HISTORIC AND DESIGN REVIEW COMMISSION

August 16, 2017

HDRC CASE NO:	**2017-413**
ADDRESS:	8514 MISSION RD
LEGAL DESCRIPTION:	NCB 11175 BLK LOT NW IRR 862.87 FT OF TR 12 (ARB 12C)
ZONING:	R-6 H RIO-6
CITY COUNCIL DIST.:	3
DISTRICT:	Mission Historic District
APPLICANT:	Joe Cannata/RVK
OWNER:	Morris Martin/City of San Antonio
TYPE OF WORK:	Construction of a multi-use trail

1 L2.01 **WAYFINDING SIGN**
3/4" = 1'-0"

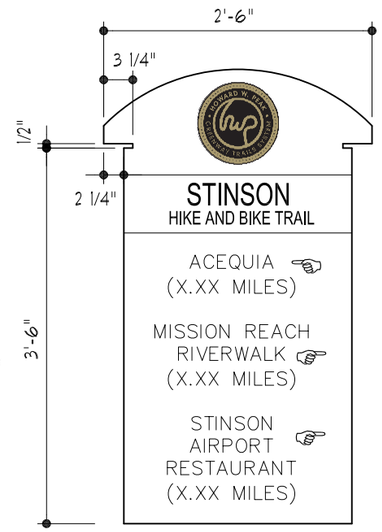
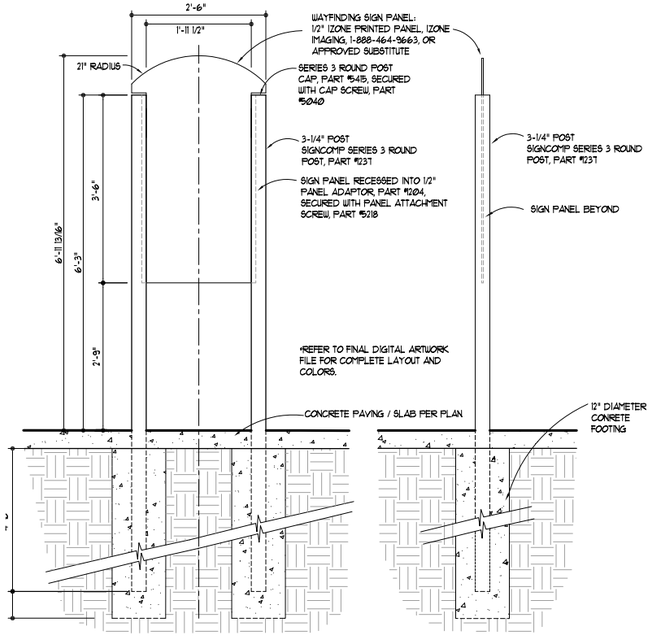
e. WAYFINDING SIGNAGE – The applicant has proposed to install wayfinding signs throughout the trail that are to be non-illuminated, be constructed of aluminum panels, and feature an overall height of either approximately 4 feet or 5.5 feet in height. Both signs will be an overall width of 2’-6”. Staff finds these proposed signs appropriate.

4 L201 **TRASH RECEPTACLE & RECYCLING**
NTS

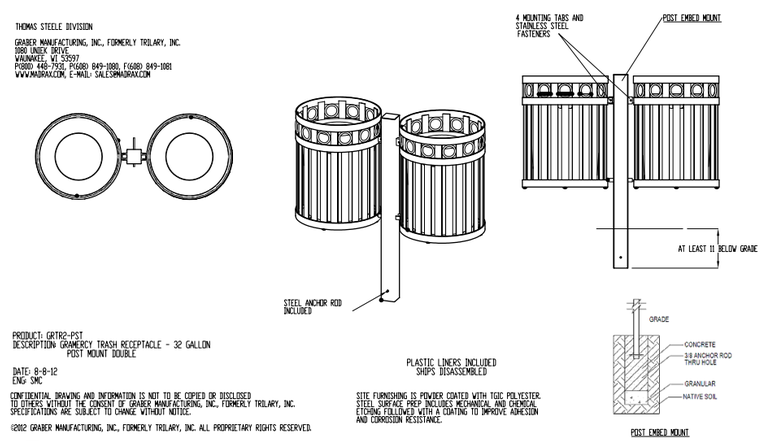
I. TRAIL TRASH RECEPTICLES –According to the UDC, receptacles should blend visually with their surroundings and their design and location should make use as convenient as possible. The proposed receptacle designs are conveniently located at trail focal points and compatible with both the proposed built and existing natural environment. Staff finds the placement and design appropriate.

1 L2.05 **KIOSK INTERPRETIVE SIGN**
3/4" = 1'-0" FRONT ELEVATION

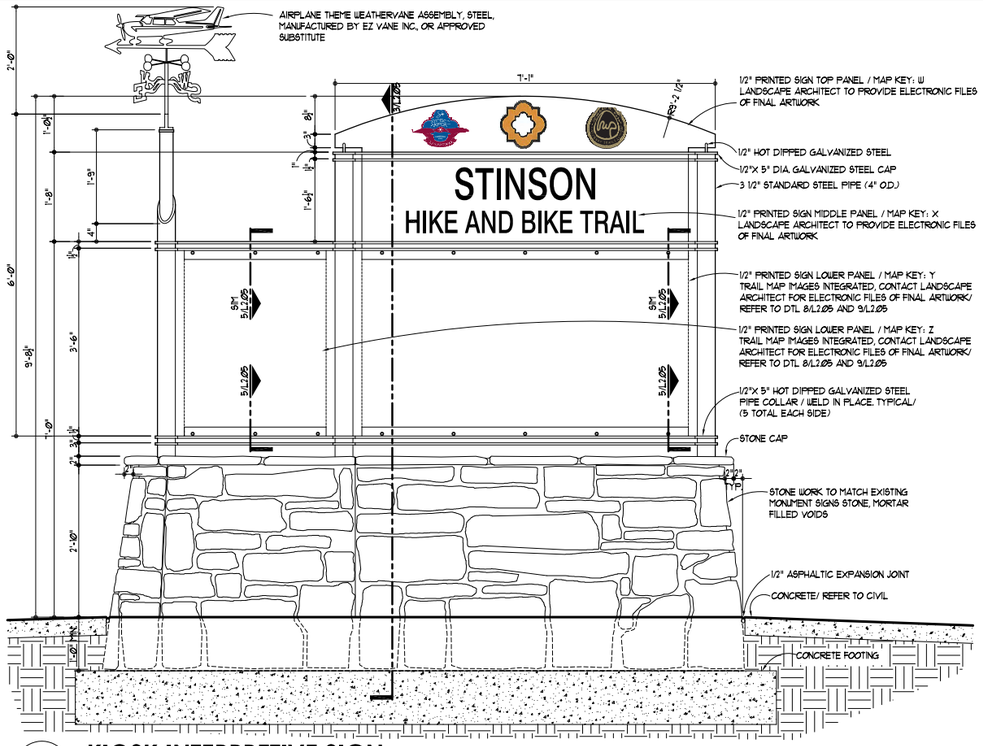
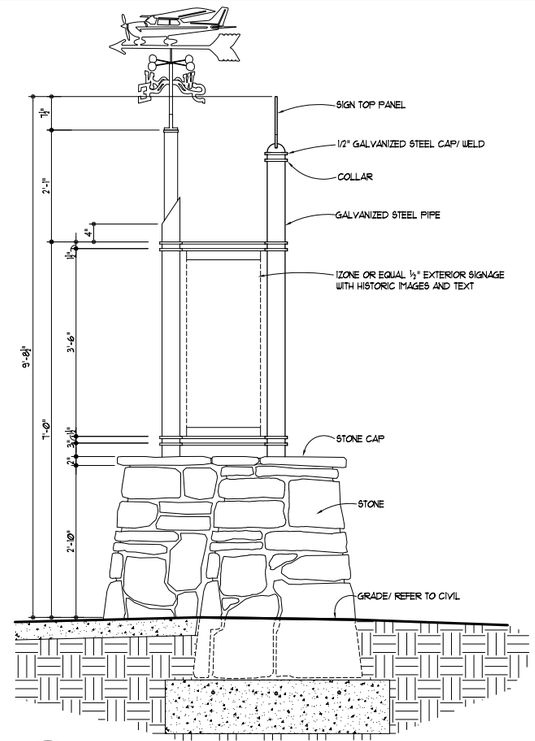
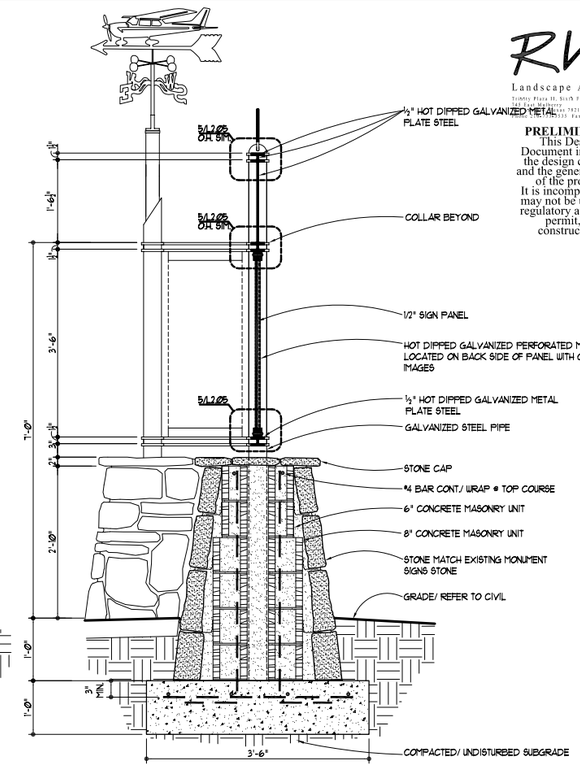
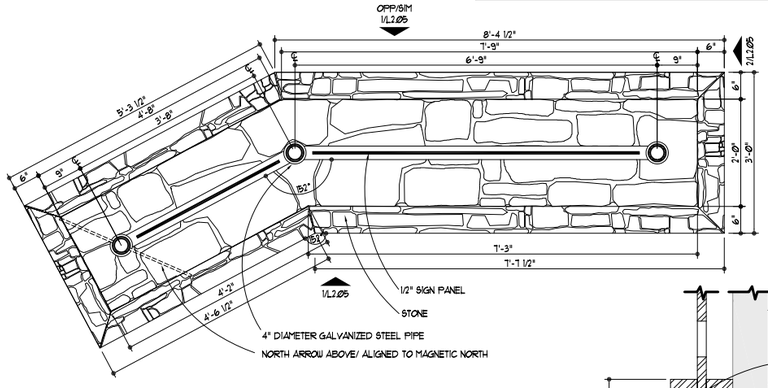
d. KIOSK SIGNAGE – The applicant has proposed to install kiosk signage near the entrance of the trail behind the Stinston Airport facility. The kiosk sign will be a height of 9’-8”, including a 2’-10” stone work base. The proposal also includes a weathervane measuring approximately 2 feet in height. According to the UDC, primary sign design considerations shall be identification and legibility. Size, scale, height, color and location of signs shall be harmonious with, and properly related to, the overall design of the building or structure and the surrounding area. The proposed sign design is legible and will feature graphics closer to eye level. The tallest portion of the sign will contain the text “Stinson Hike and Bike Trail” to be readable from a distance. Staff finds the proposed signage appropriate in regards to location, size, and design.

SIGN KIOSK AT PAVED TRAILHEAD

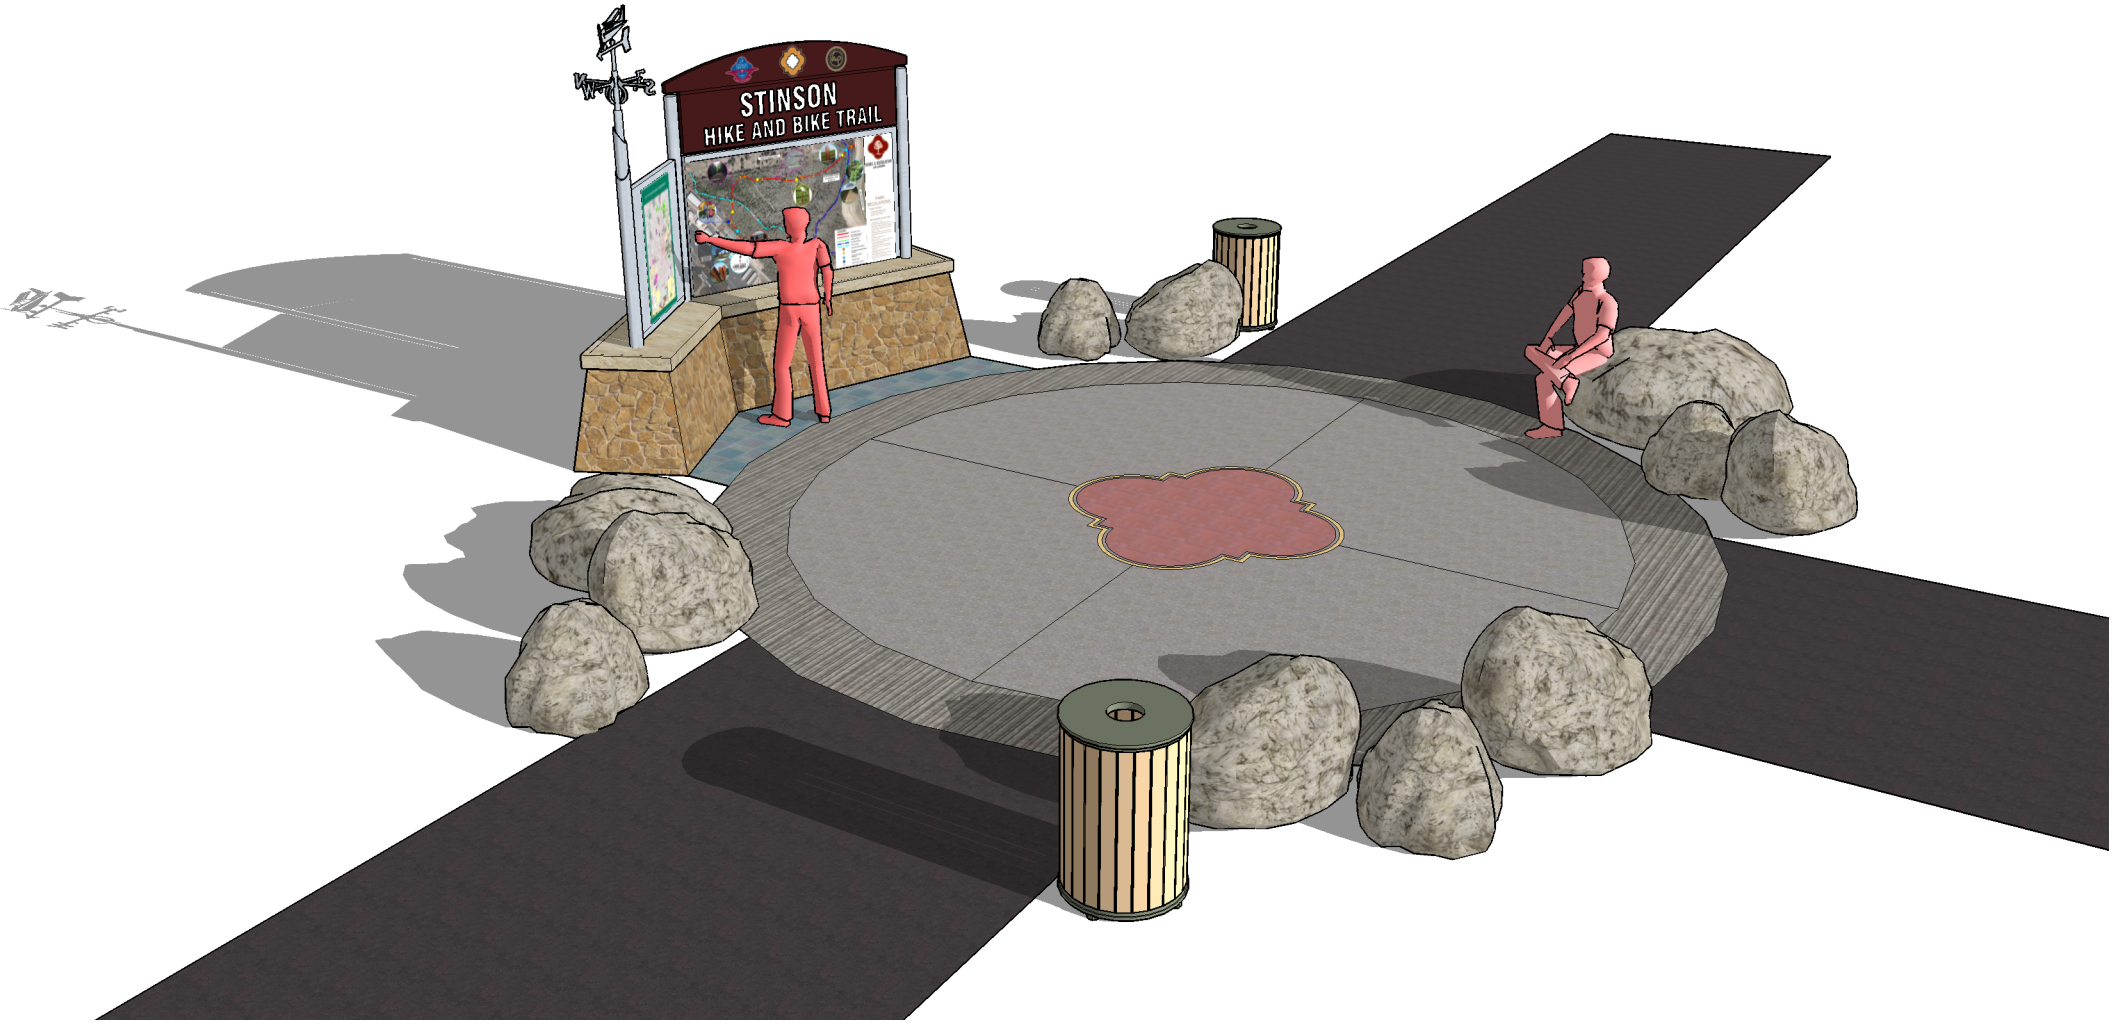
b. TRAIL PAVING – The proposed trail will be constructed of concrete trailhead paving. The paving will change color and texture at points in the trail where multiple pathways meet or kiosk signage is introduced. According to the UDC, walkway or paving materials should be chosen for beauty, strength, longevity, easy maintenance and traction when dry or wet. Changes in surfaces should be defined by contrasting color, texture or materials to ensure pedestrian safety. The material is also compatible for its proposed use. Staff finds the proposed trail material appropriate.
